AMENDMENTS TO THE DRAWINGS:

The attached drawing sheets include amended and marked-up versions of Figures 3, 15 and 16. Figure 3 is amended to correct an error in the spelling of the word “Network”. Figures 15 and 16 are amended to include a numerical designation for the entire structure shown in each Figure.

Attachments: Marked-up version of Figures 3, 15 and 16 are included at Appendix A.

Appendix A

Fig.16.

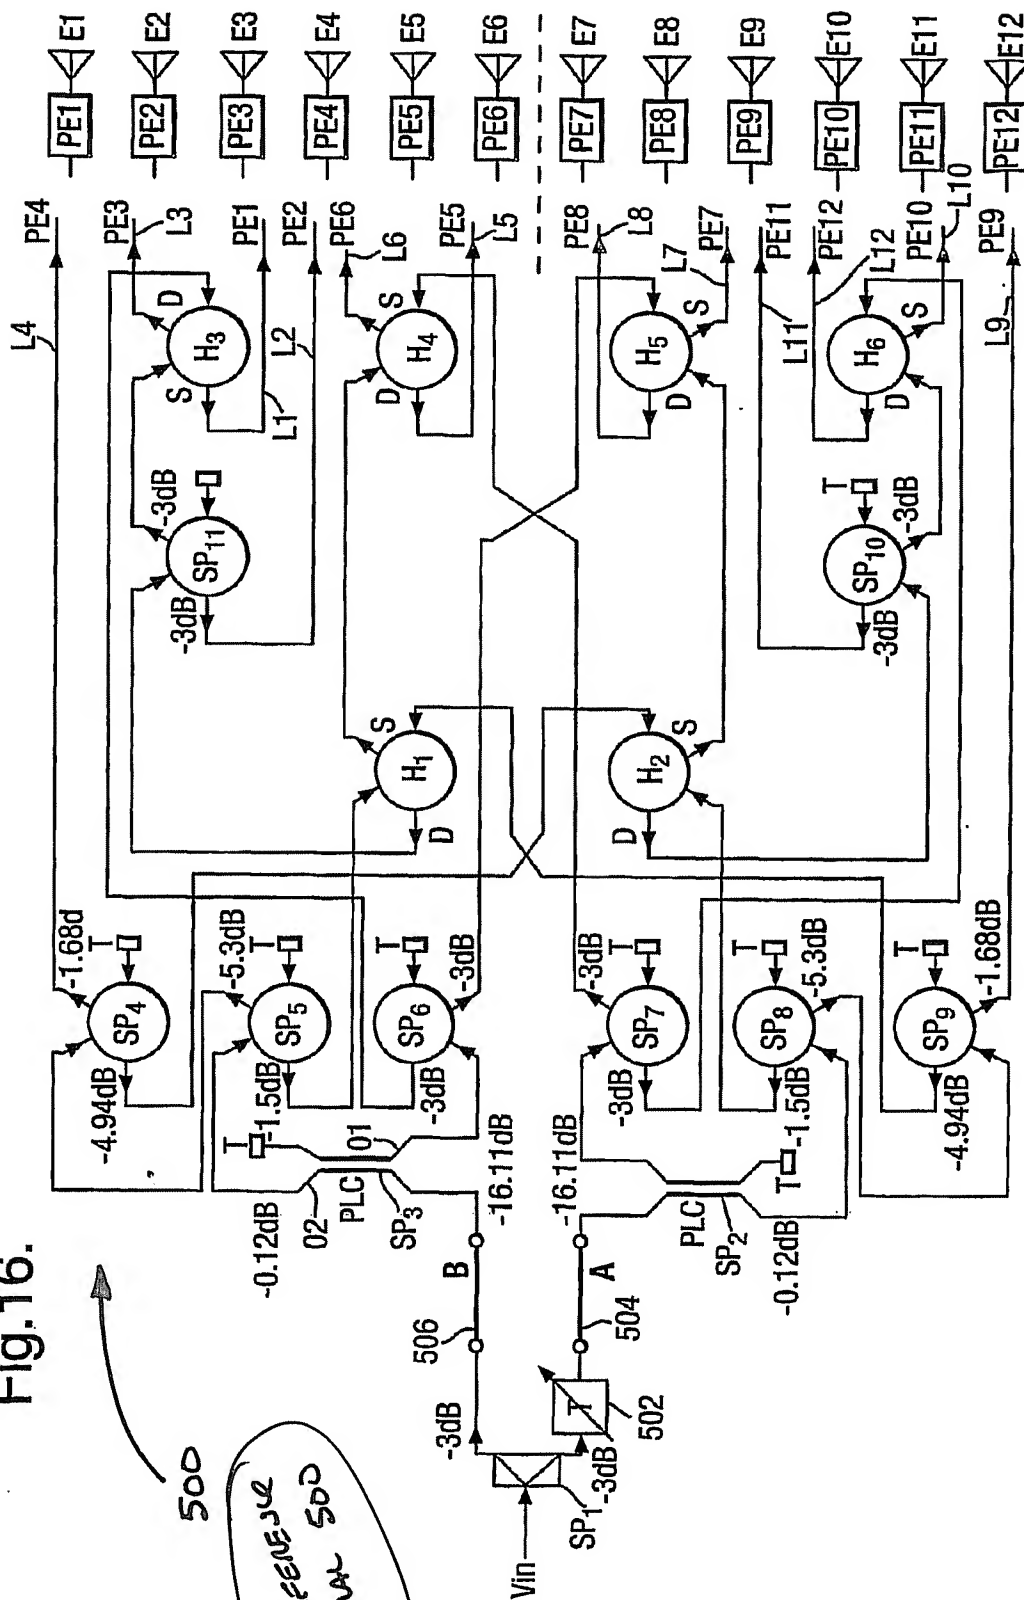
ADD REFERENCE
SIGNAL 500
